2013 Leon Creek Water Recycling Center (WRC) Rehabilitation and Process Improvements

SAWS Job No.: 13-6505

Addendum No. 5

August 20, 2015

4. Page 6, Paragraph 2.01.E.5:

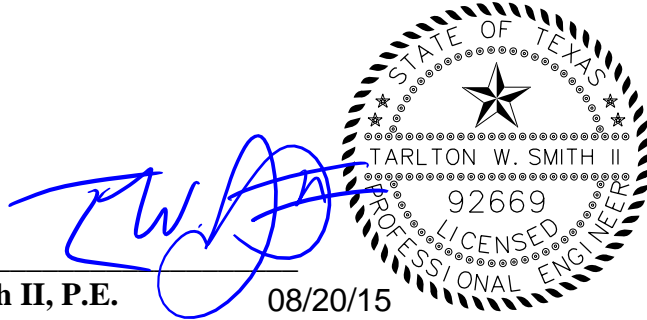
REMOVE “...7,000 psi.”

And REPLACE with: “...6,500 psi.”
